STATE OF VERMONT
AGENCY OF TRANSPORTATION

PROPOSED IMPROVEMENT
BRIDGE PROJECT

MARLBORO
BRF 010-1 (43)

RECORD PLANS	
CONTRACTOR:	RENAUD BROTHERS, INC. - VERNON, VT
RESIDENT ENGINEER:	RON LEMAIRE
CONSTRUCTION BEGAN:	APRIL 8, 2014
CONSTRUCTION COMPLETE:	NOVEMBER 6, 2014
RECORD PLANS BY:	RON LEMAIRE & JENNA HYDE
I HEREBY CERTIFY THAT ALL THE CONSTRUCTION REQUIRED BY THIS SET OF DRAWINGS HAS BEEN ACCOMPLISHED AS INDICATED HEREIN.	
BY	RESIDENT ENGINEER
DATE 02/11/2016	
NOTE: Any further information concerning final quantities, amounts or other details relative to this project may be found at Central Files in the electronic archives.

PHASE 1
SCALE: 3/8" = 1'-0"

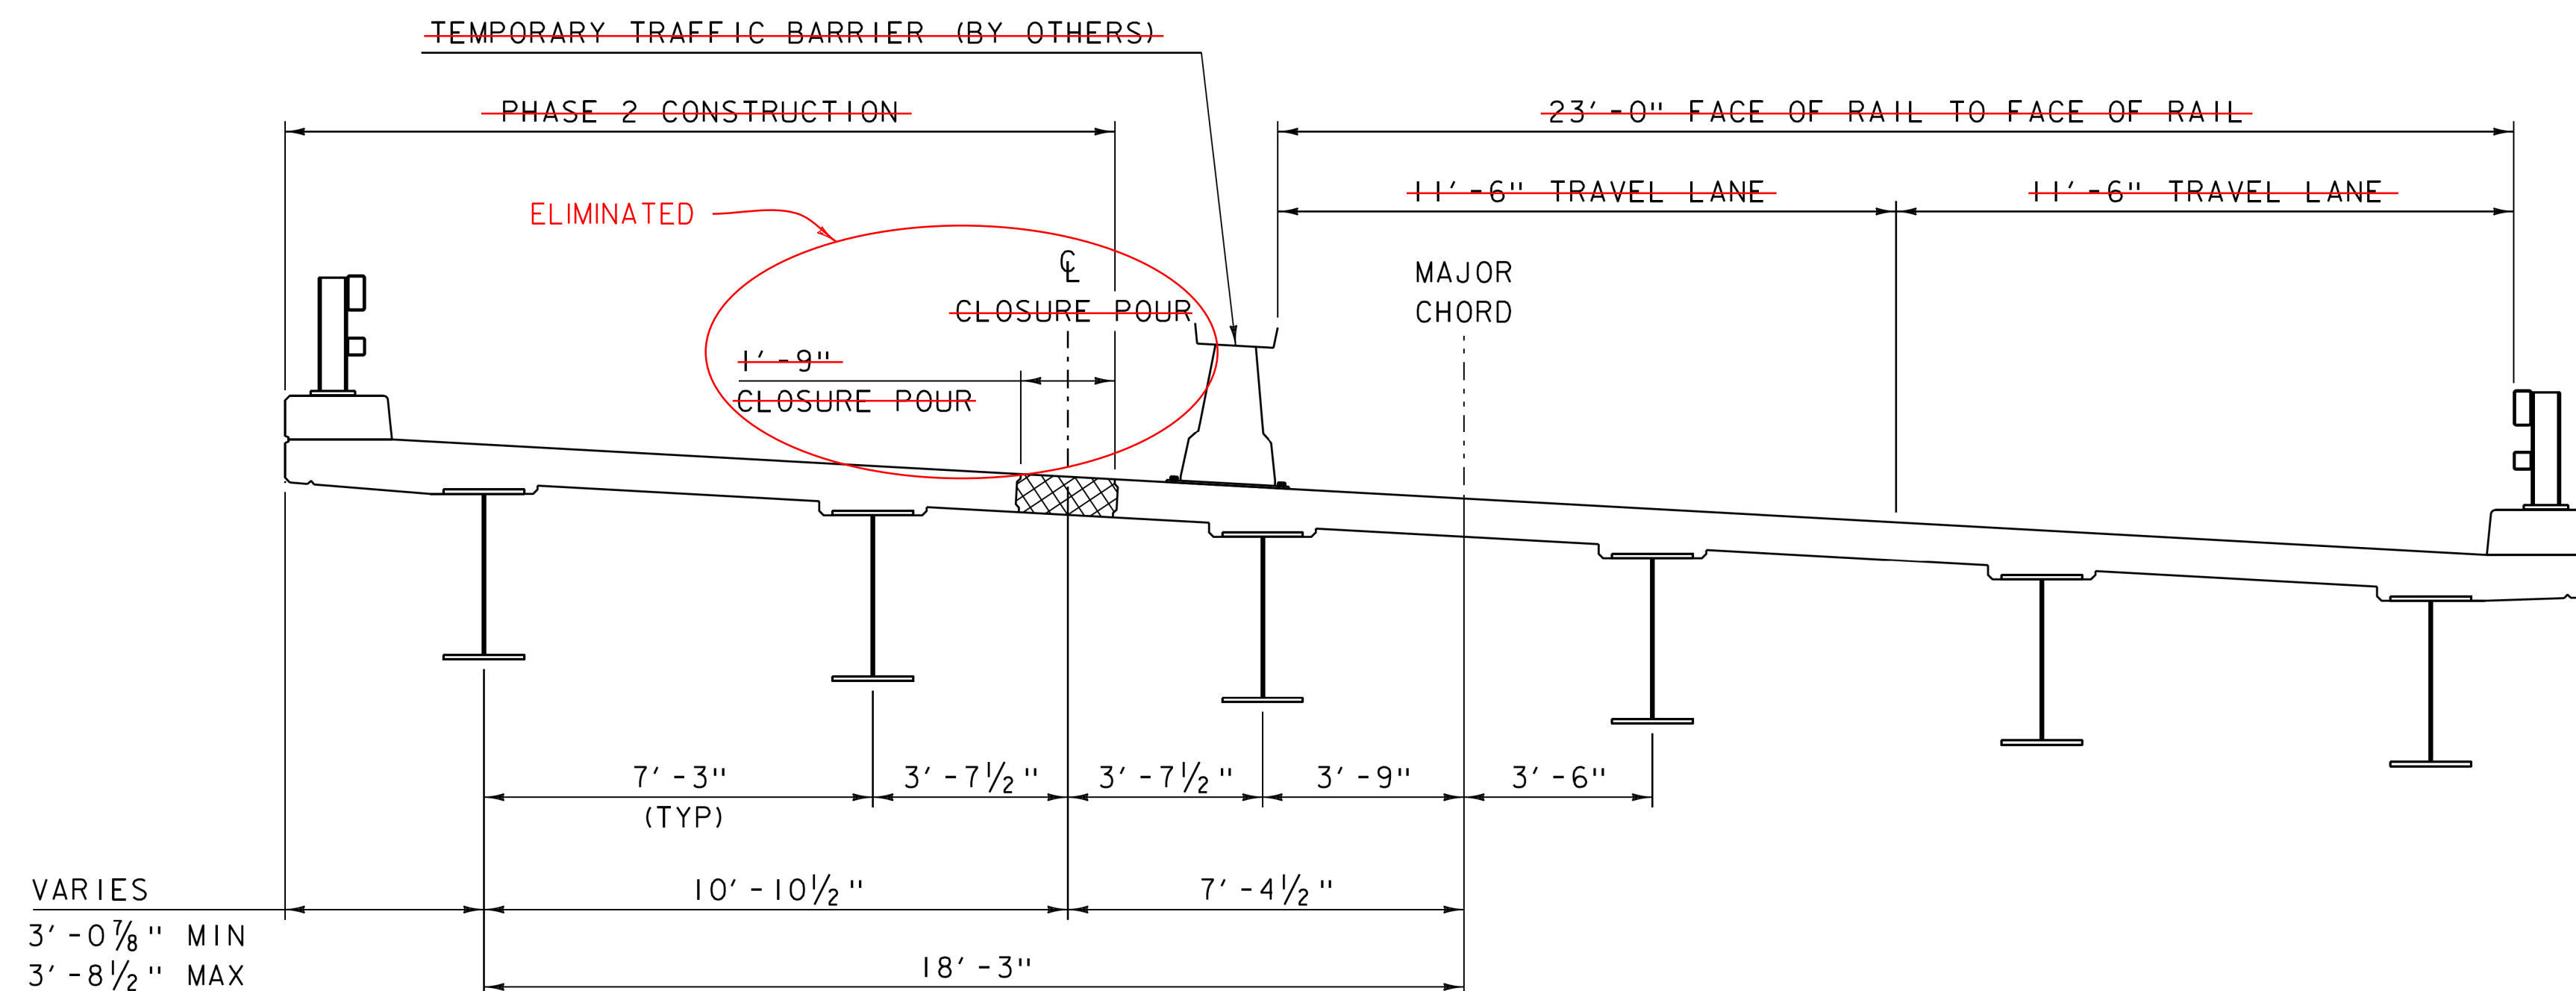
CONTRACTOR WAS ABLE TO PLACE GIRDERS AND DECK WITHOUT PHASING. TRAFFIC WAS KEPT ON TEMPORARY BRIDGE THROUGHOUT. DECK WAS PLACED FULL WIDTH.

CLOSURE POUR DETAIL PLAN
SCALE 2" = 1'-0"

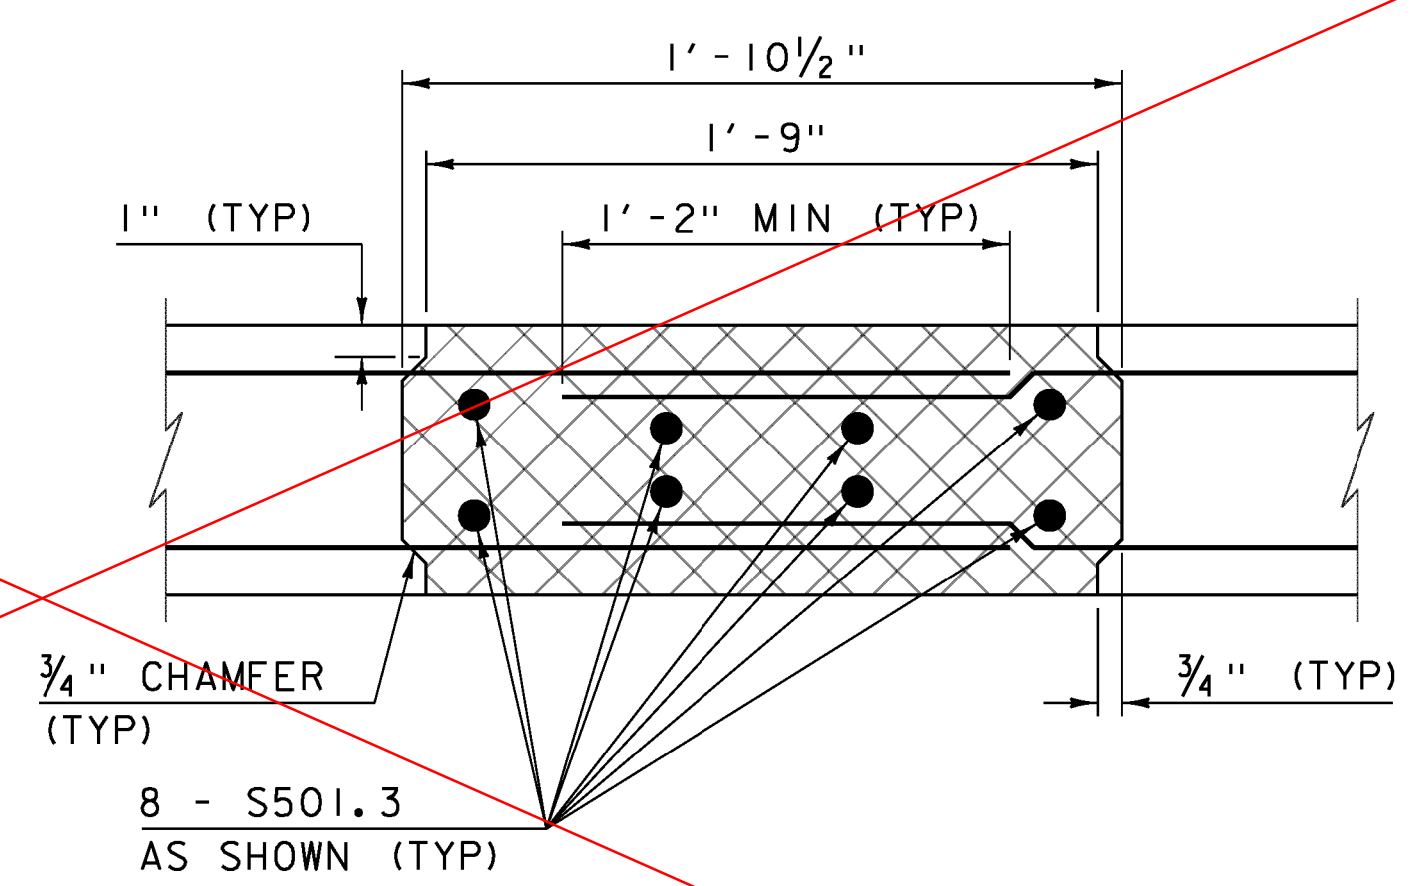
ELIMINATED - DECK CONSTRUCTION FULL WIDTH

APPROACH SLAB #2 PLAN VIEW

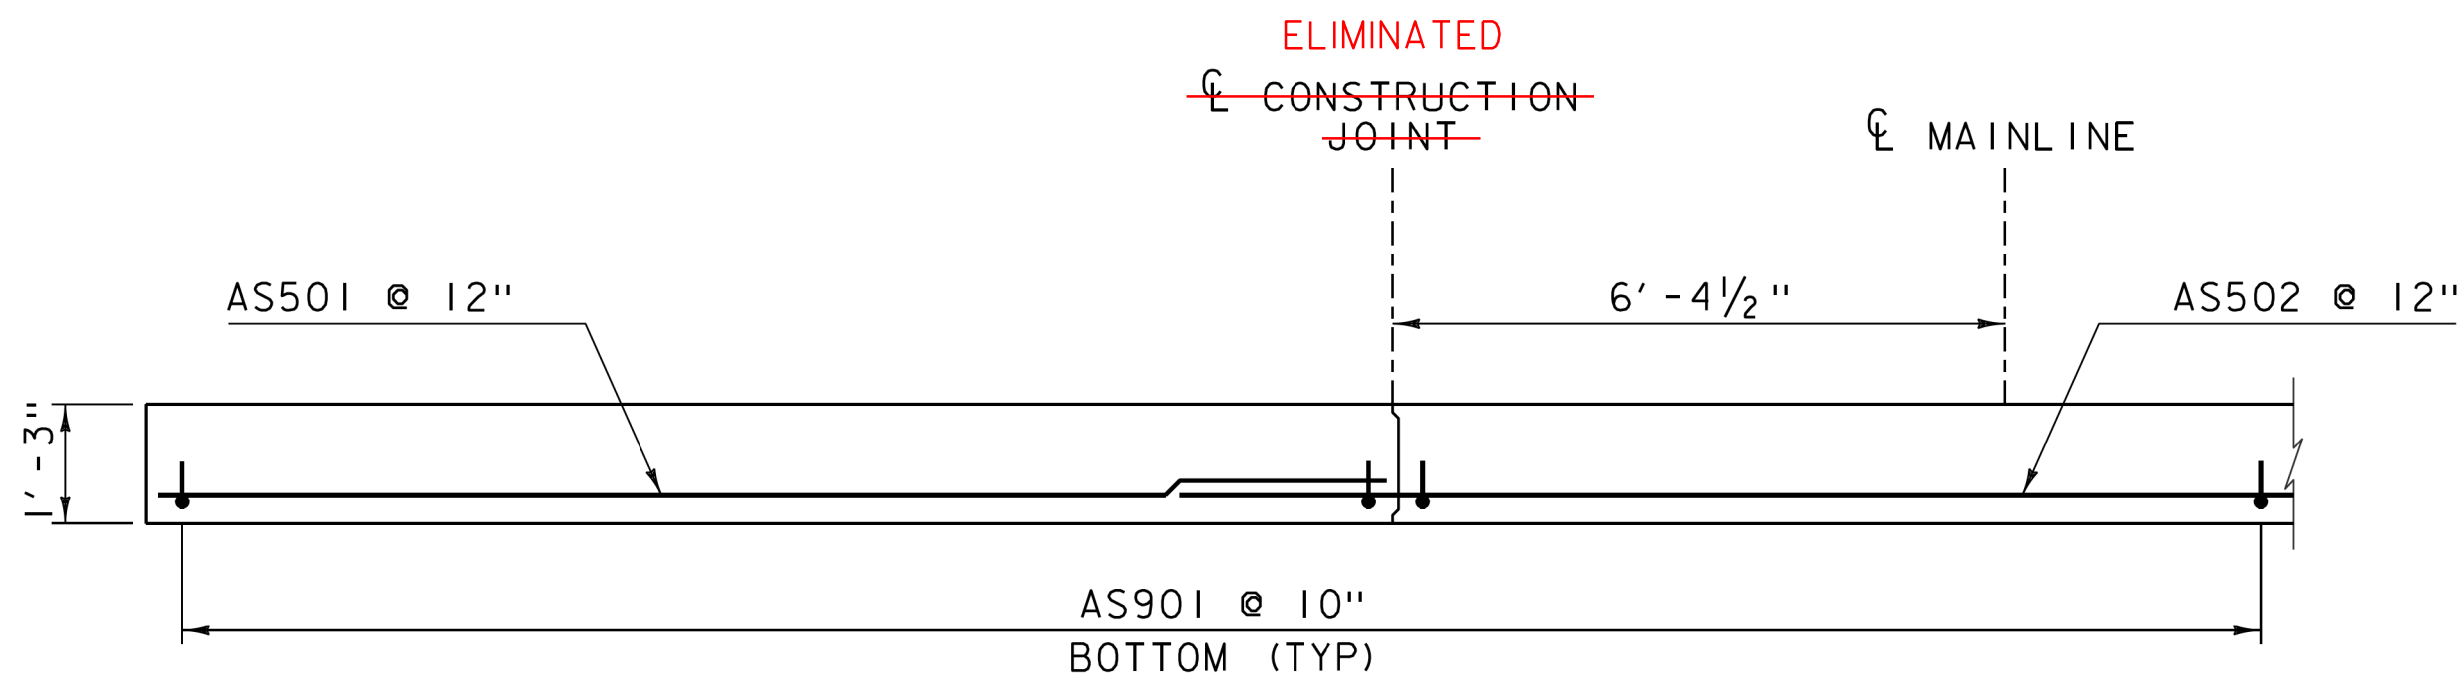
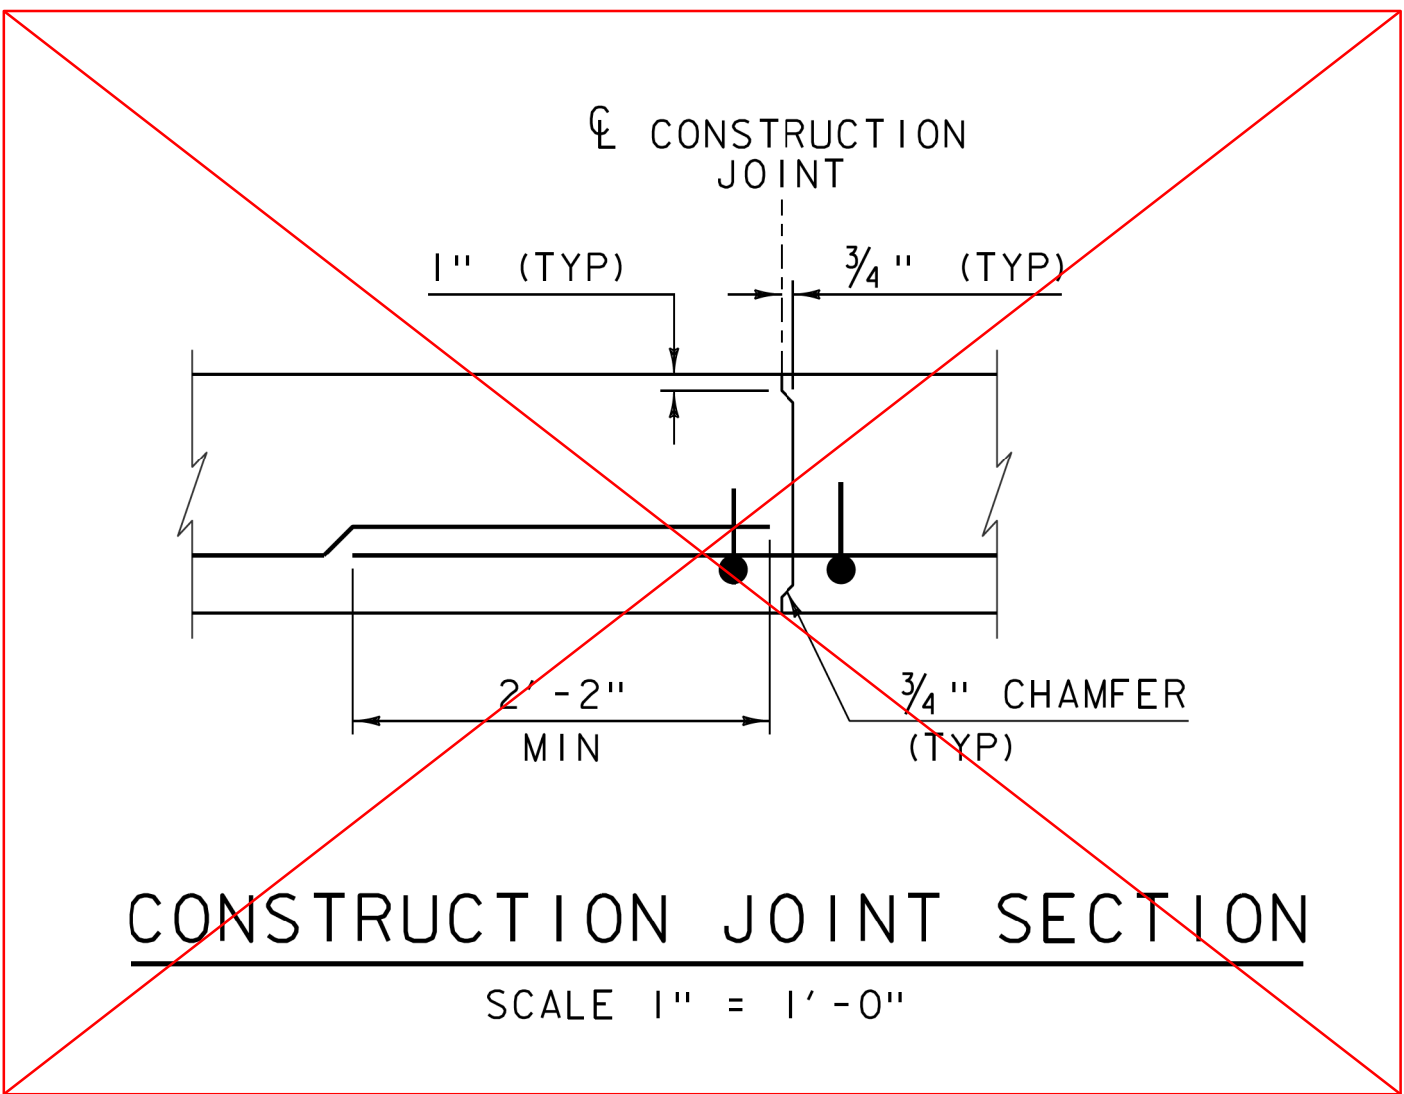
APPROACH SLABS WERE PLACED FULL WIDTH,
TRANSVERSE REBAR - IAS501& IAS502 WERE
STAGGERED
